**RE: Clarification regarding Condition of Approval #8 of the Traffic Study and Addendum for  
The Two Fifty, SDR-62393 & DIR 63602, T64341**

The Transportation Engineering Division has reviewed and approved the traffic study and addendum for The Two Fifty, to be located on the southwest corner of Alta Drive and Rampart Boulevard. Per this study, the project is proposed to consist of 60 single-family detached dwelling units (SFDUs) and 3,020 multi-family dwelling units (MFDUs). Condition #8 states:

**RE: Traffic Study and Addendum for The Two Fifty, SDR-62393 & DIR 63602, T64341**

**THE TWO FIFTY**

Figure 18. Background-Plus-Project – PM Peak Scenario 1

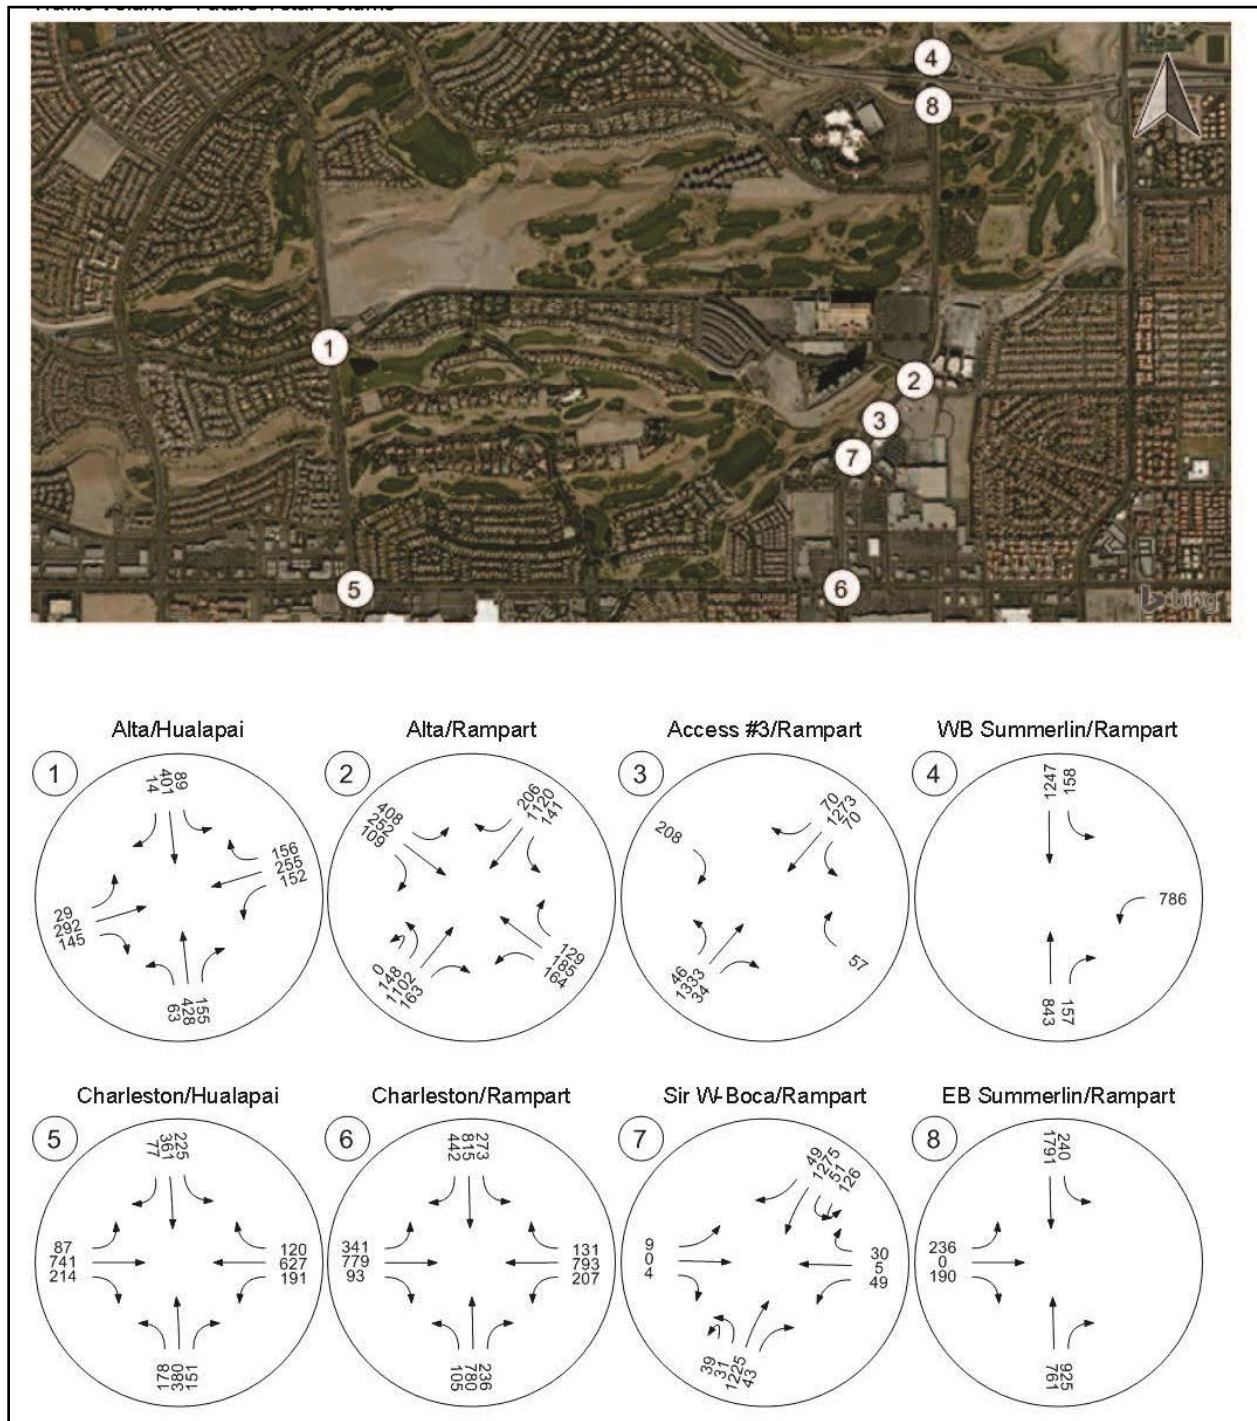
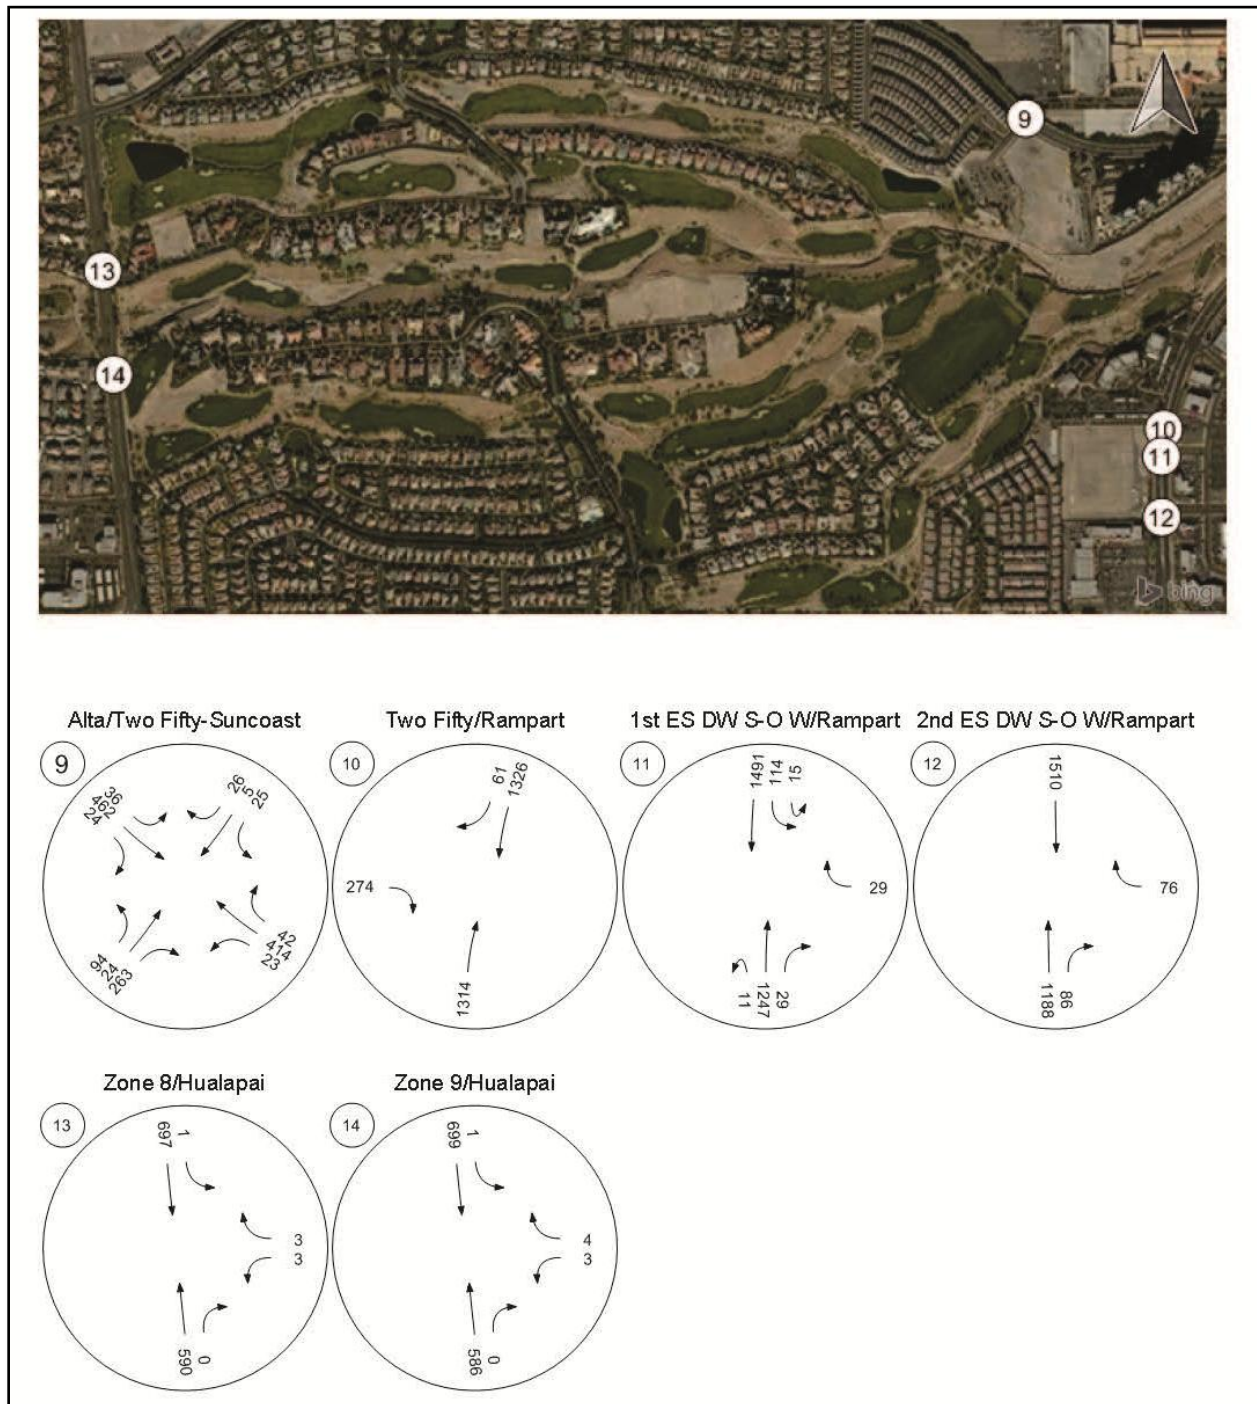
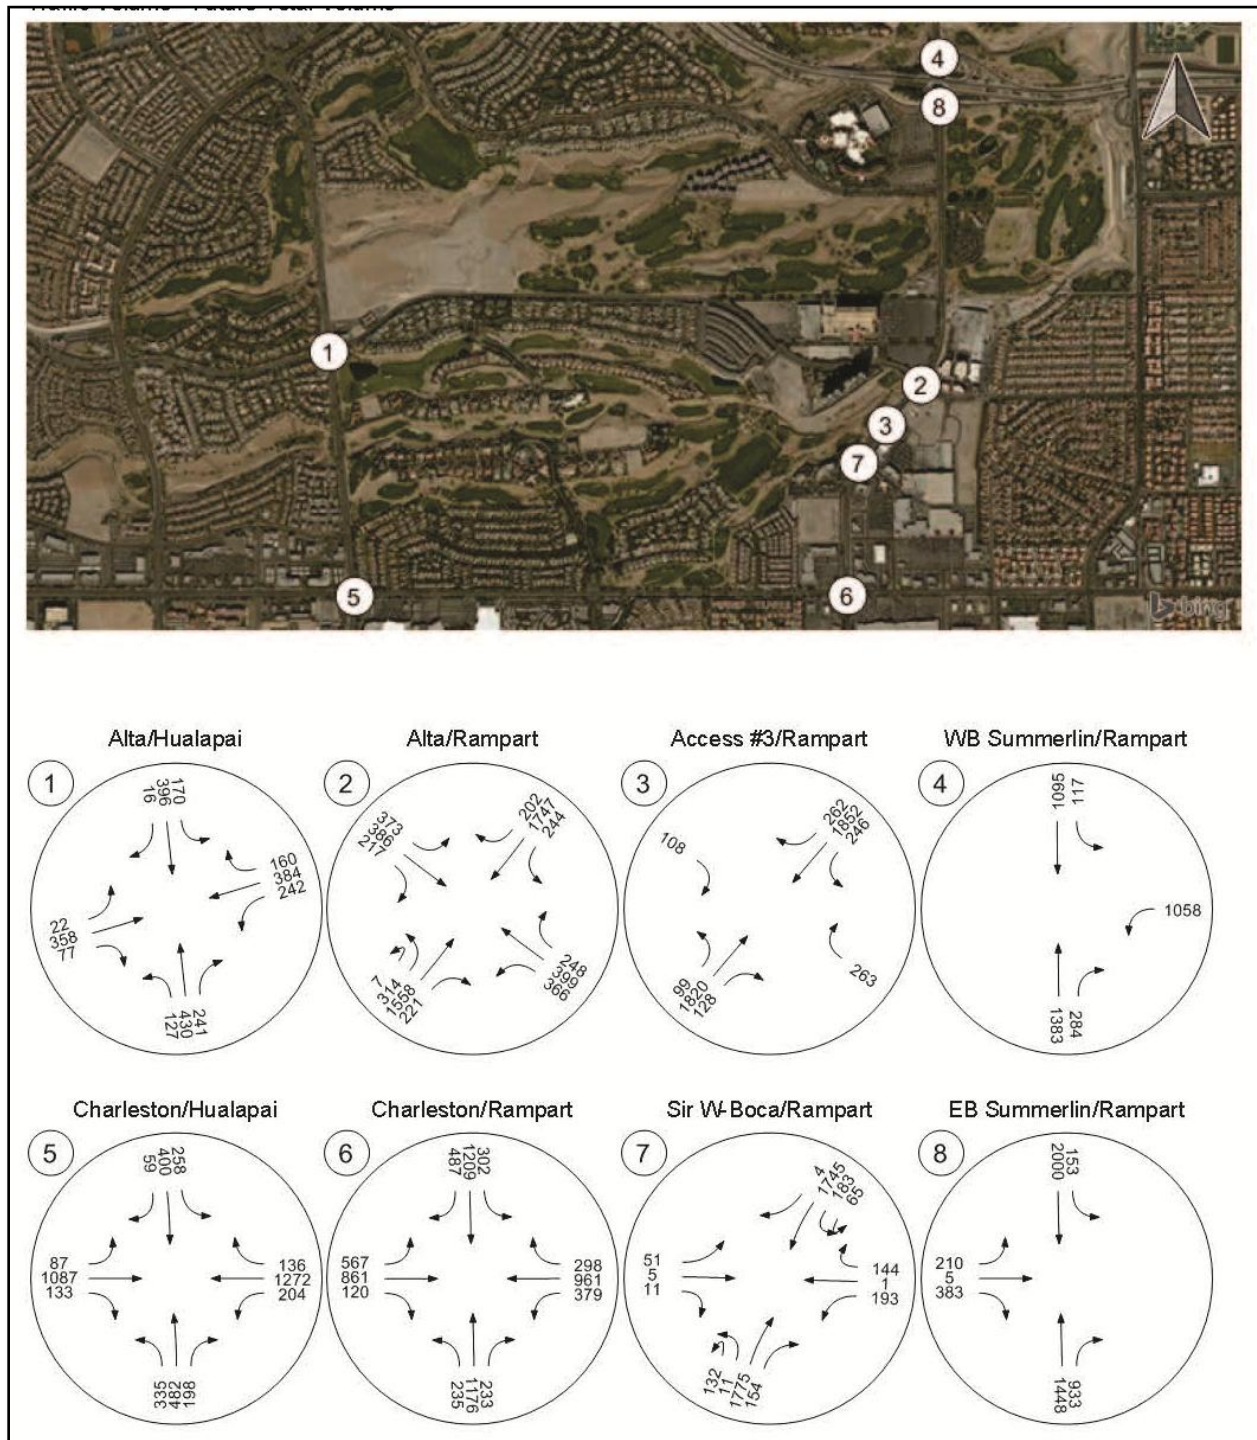
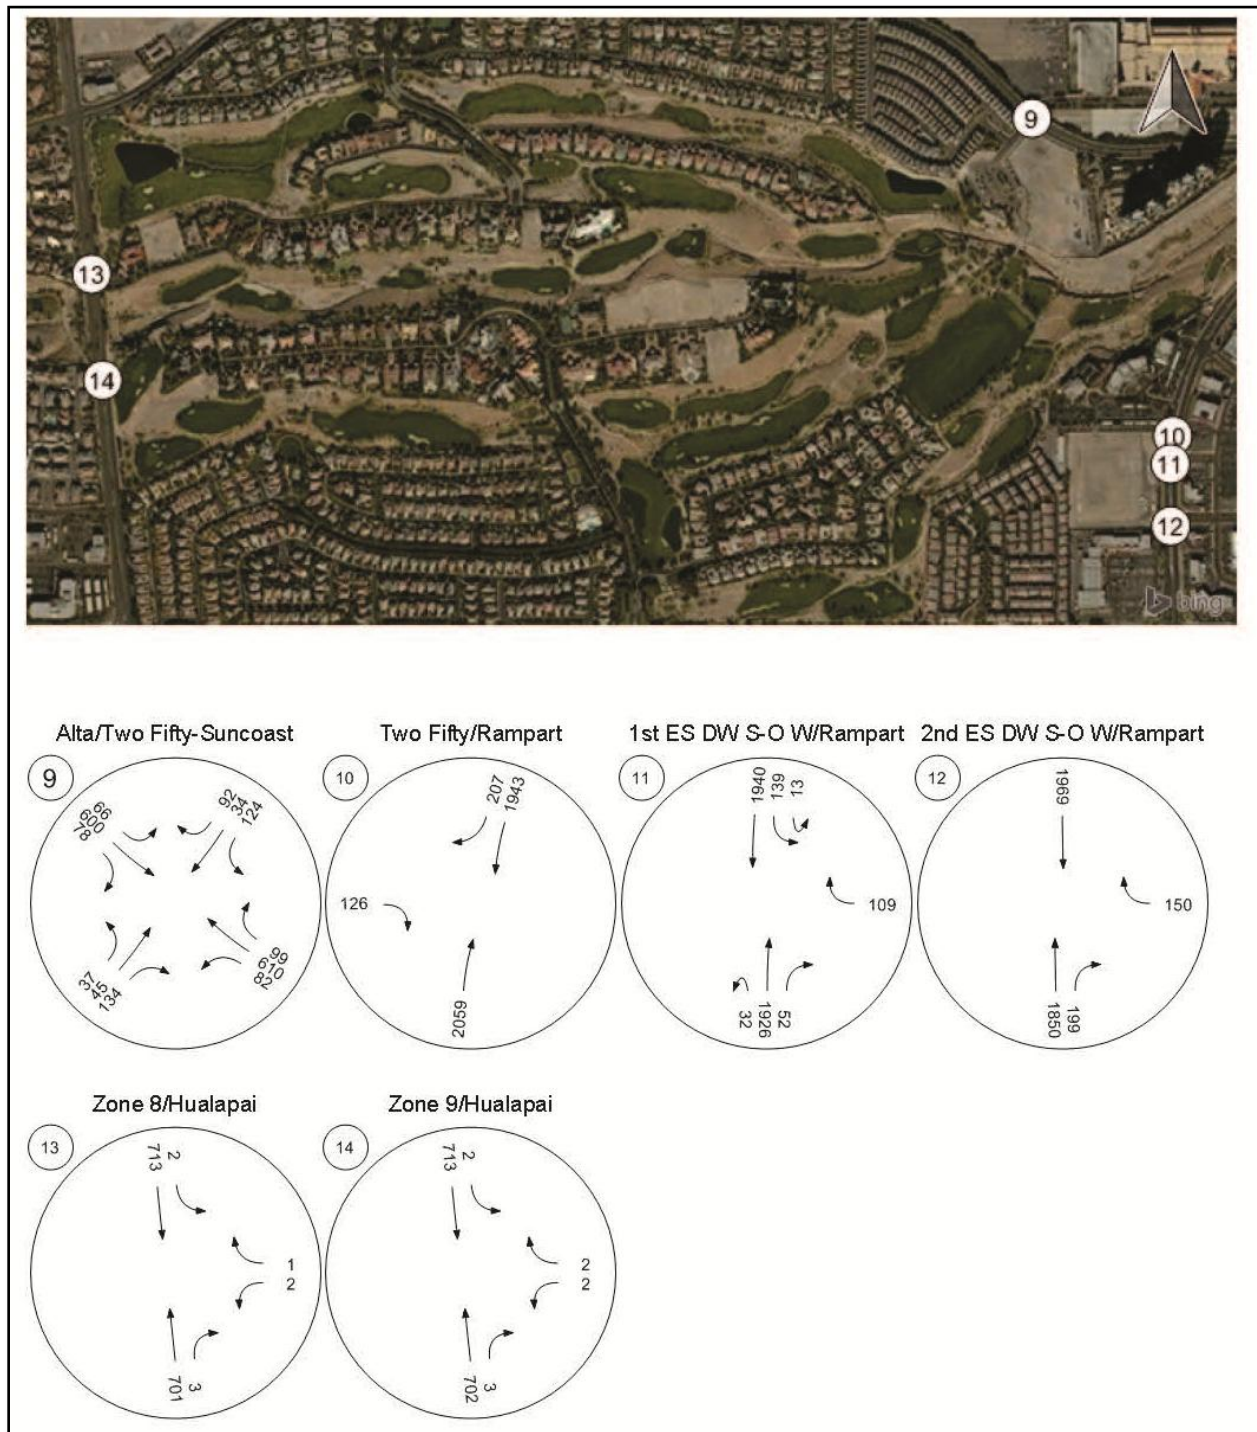
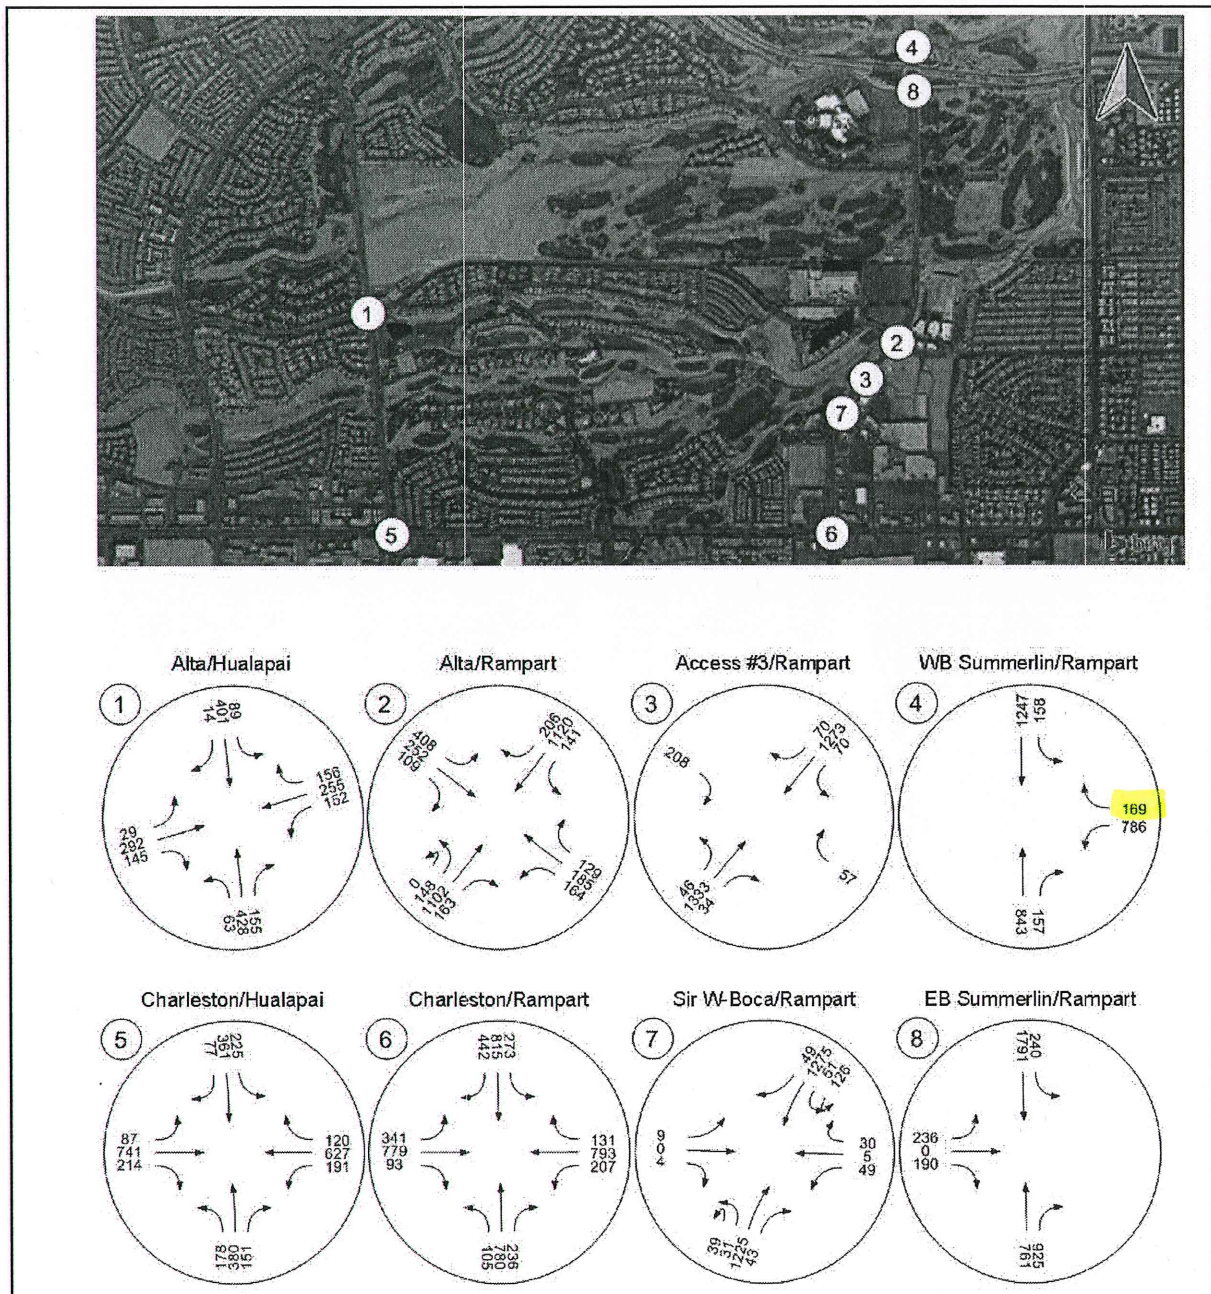
**Comment:** "1. On Figures 17 and 18, Background-Plus-Project AM and PM peak Scenario 1, the westbound left turning volumes for intersection 4 (Westbound Summerlin Parkway and Rampart) were left off.

**Response:** Please find revised Figures 17 and 18 attached. Westbound *right-turning* volumes have been added (169 vph in the AM peak hour and 250 vph in the PM peak hour).

**Comment:** "2. On Figure 18, Background-Plus-Project PM peak Scenario 1, the following volumes appear to be in error:

2. On Figure 18, Background-Plus-Project PM peak Scenario 1, the following volumes appear to be in error:
  - a) Intersection 11 (1st ES DW S-O W/Rampart), westbound rights shown as 1928; should be 1916.

**Response:** Please find corrected Figures 10, 11 and 13 for background traffic attached. The change in left-turn and U-turn access was assumed to have a minor impact on the distribution of background right-turn demands. The corrected volumes added to Figure 16 trip assignments yields the Figure 18 volumes.
